Report to the Manitowoc Plan Commission

Meeting Date: April 26, 2017

Request: (PC 11-2017) Manitowoc Public Utilities; Review of Placement of a Wind Screen Structure pursuant to § 62.23(5)

WIND FENCE PROPOSED LAYOUT

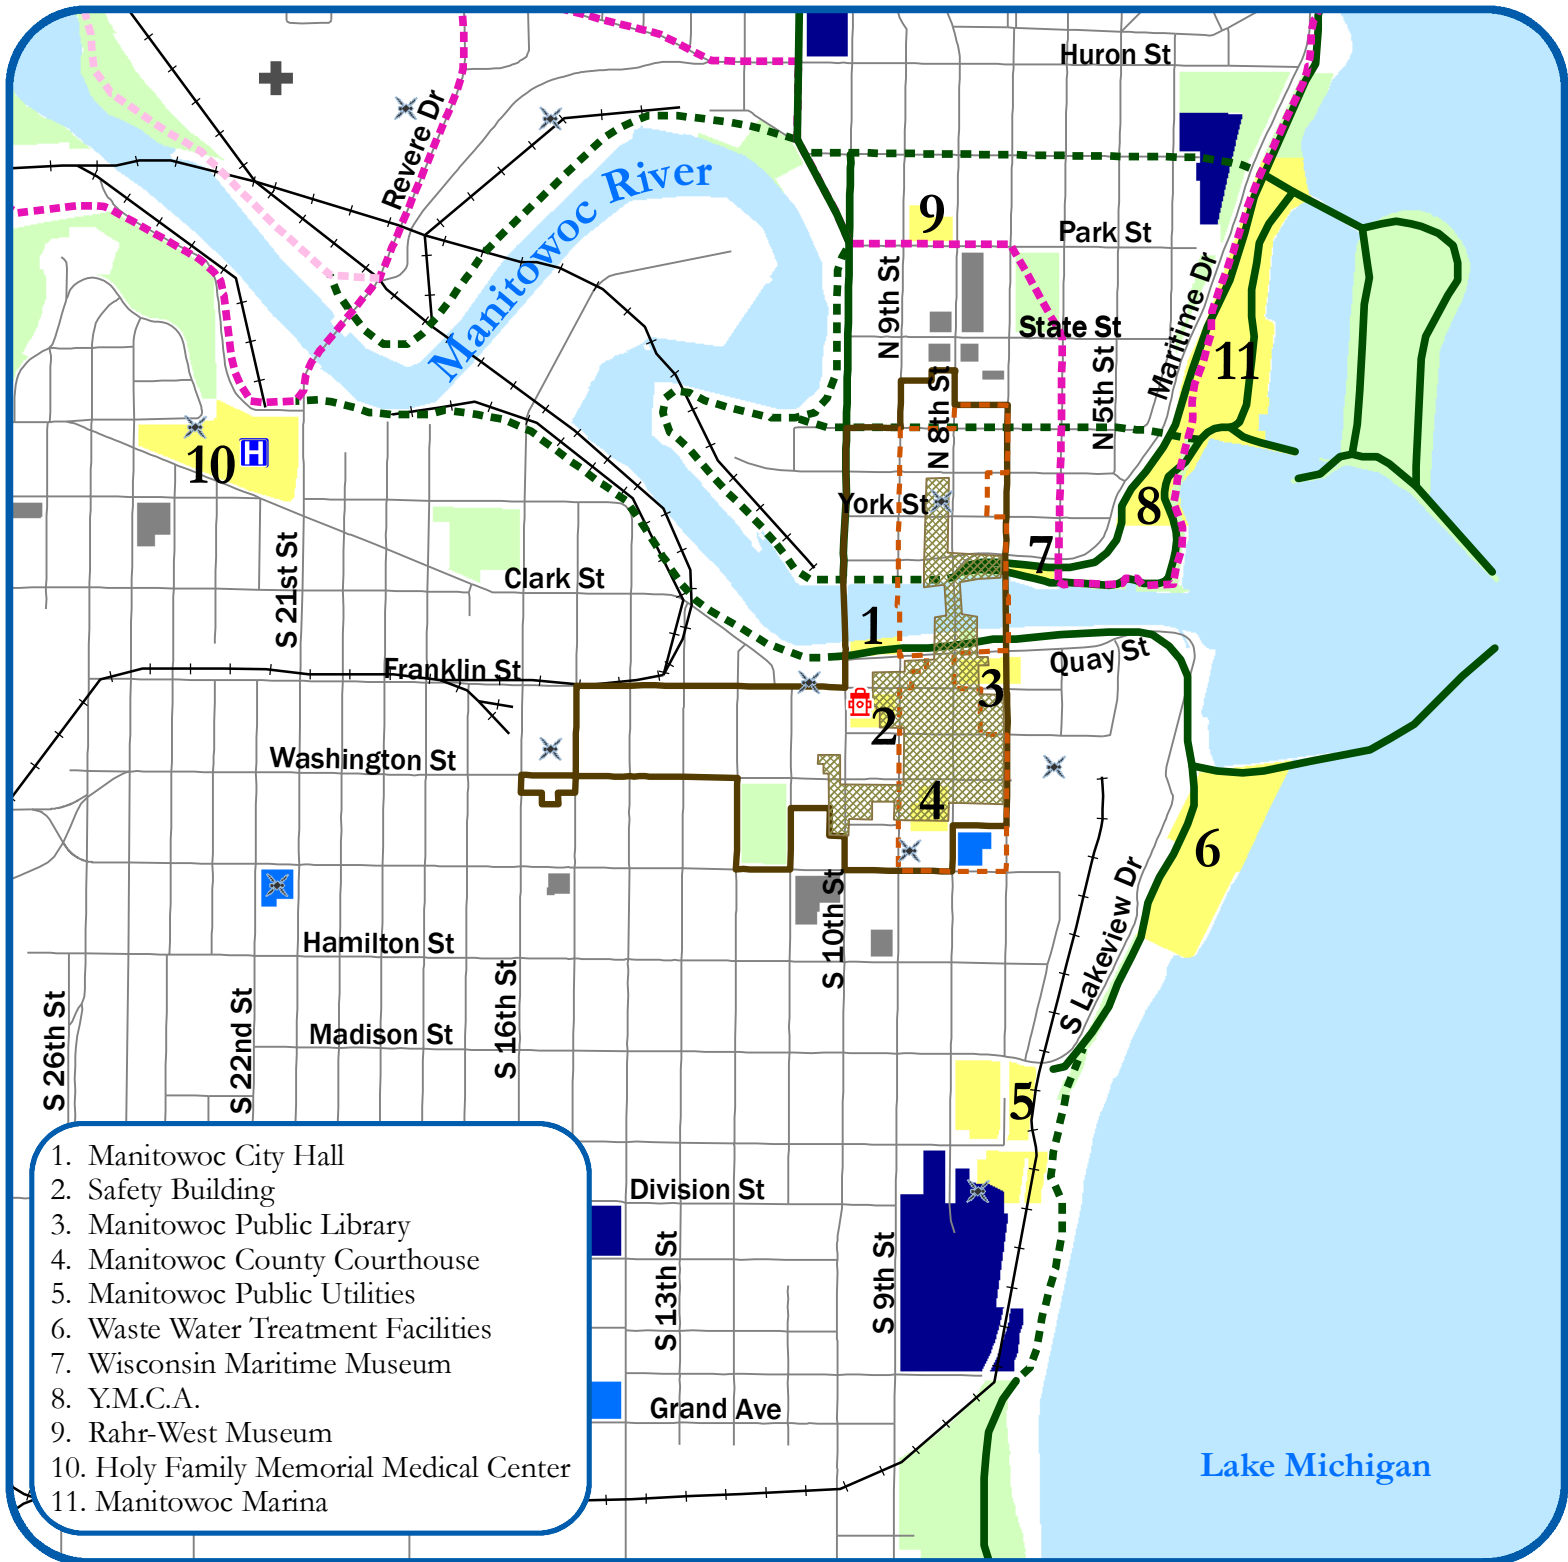
Potential impact to the ability to construct a future trail connection is the primary concern with any alterations to this portion of the MPU site. On the positive side, providing some visual screening of the coke pile and adding dust control should be beneficial to the community and environment.

The proposed placement of the wind fence between the existing security fence and the concrete barrier as shown on the attached site plan appears to minimize potential impacts on a future trail. This assumes that MPU does not need to maintain any setbacks between the wind fence and other potential uses. This also assumes that the City will be able to utilize its Lake Bed Grant area to construct a future trail foundation.

Recommendation: The Community Development Department finds that the wind fence is a necessary alteration to the Manitowoc Public Utilities property and recommends approval. We further request that Manitowoc Public Utilities cooperate with the City on plans for a future trail connection at such time that a feasibility study moves forward.
